WAKE ROBIN INN REDEVELOPMENT

104 & 106 SHARON ROAD & 53 WELLS HILL ROAD
SALISBURY, CONNECTICUT

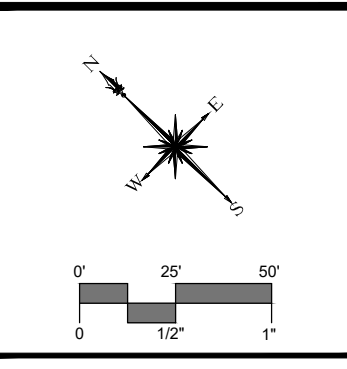
DESCRIPTION	DATE	BY
PAZ SUBMISSION	8/12/2024	SM
PEER REVIEW COMMENTS	8/8/2024	DSR
TOWN COMMENTS	11/16/2024	SM

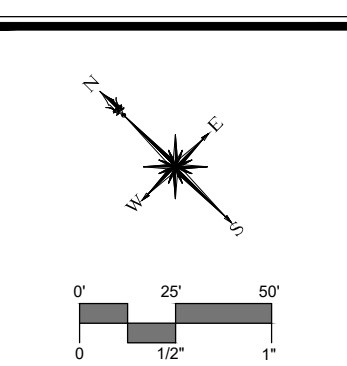
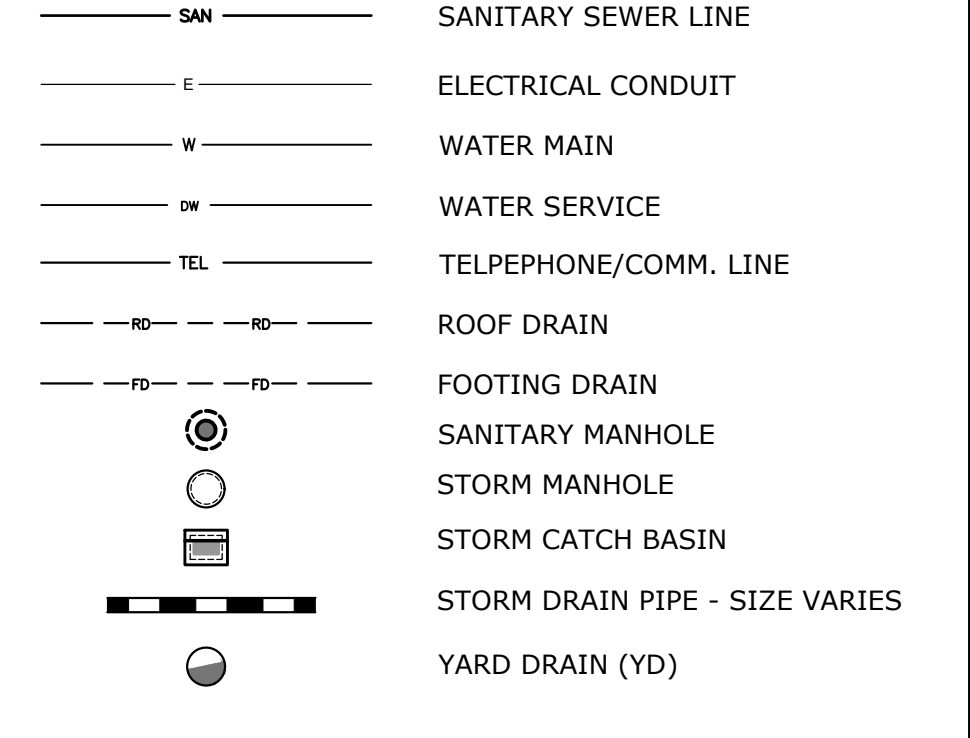
DESCRIPTION	DATE	BY
PAZ SUBMISSION	8/1/2024	SM
PEER REVIEW COMMENTS	8/8/2024	DSR
TOWN COMMENTS	11/8/2024	SM

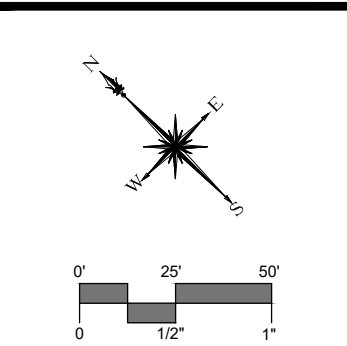
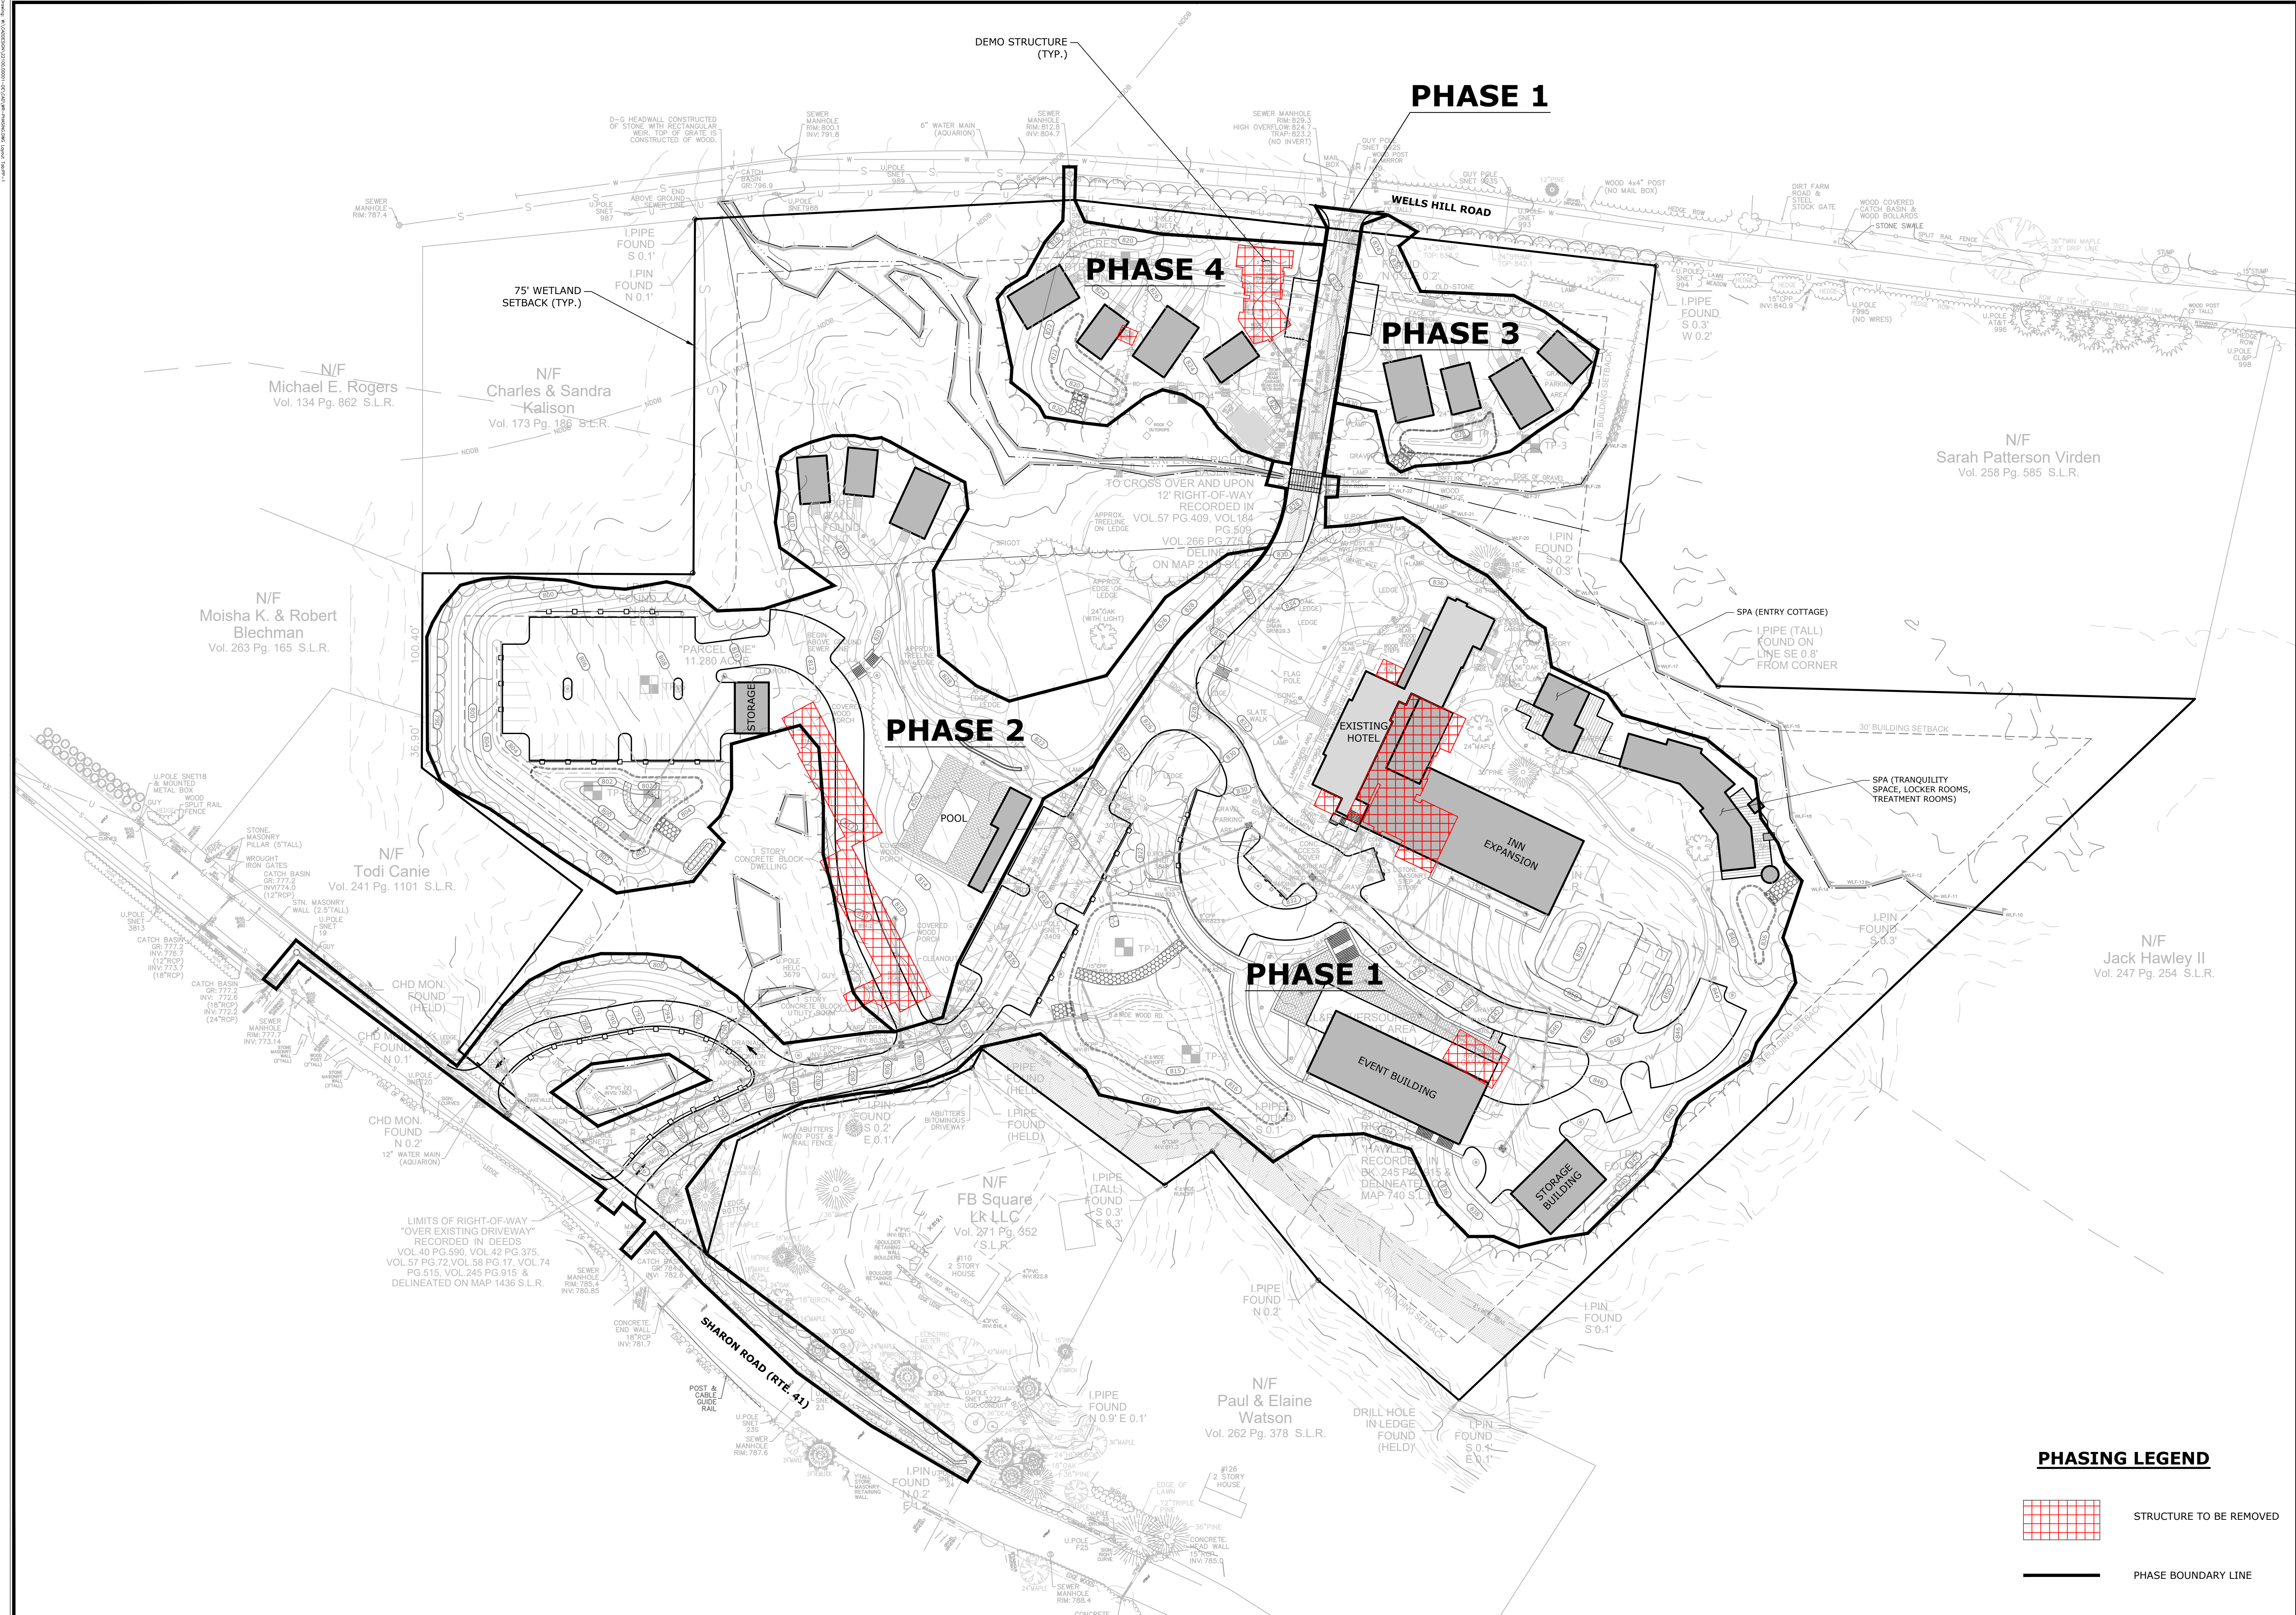
DESCRIPTION	DATE	BY
PEER REVIEW COMMENTS	8/8/2024	DSR
TOWN COMMENTS	11/16/2024	SM

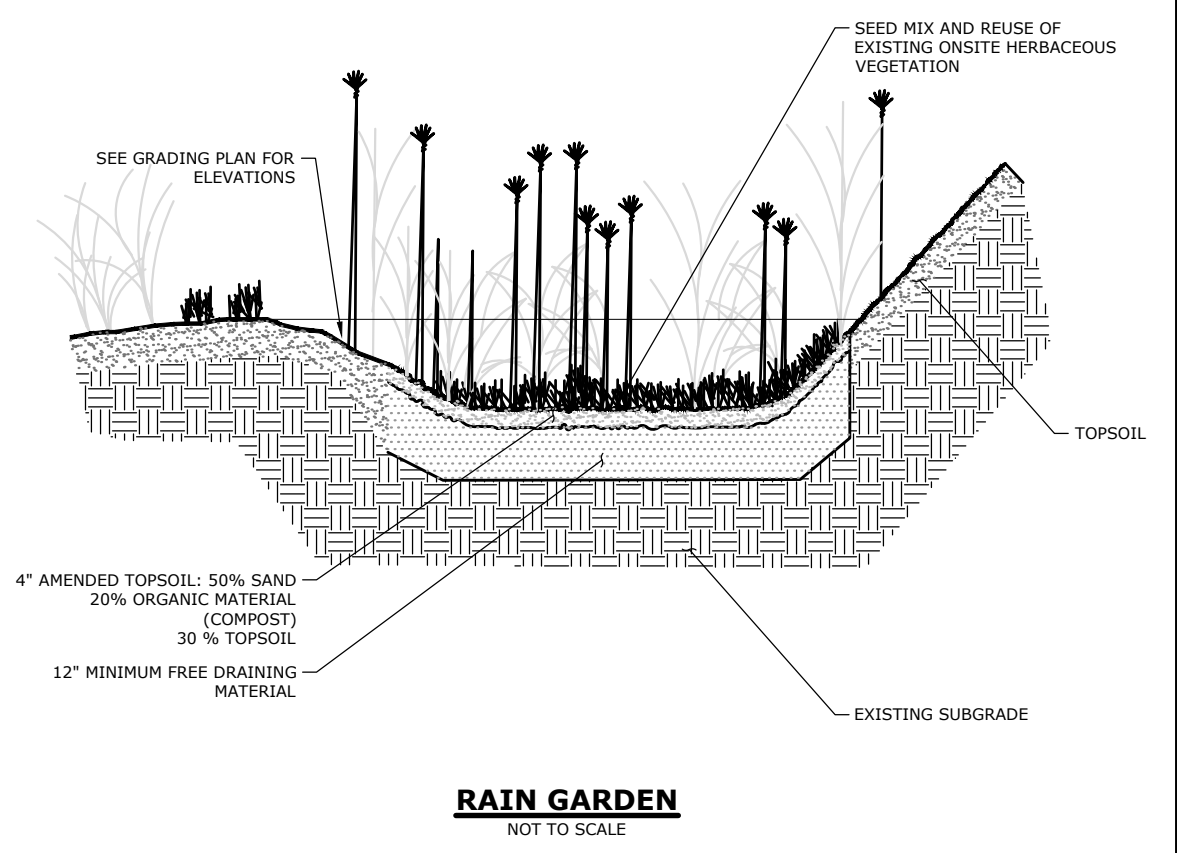
DESCRIPTION	DATE	BY
PKZ SUBMISSION	8/1/2024	SM
PEER REVIEW COMMENTS	9/11/2024	MCB
TOWN COMMENTS	11/8/2024	MCB
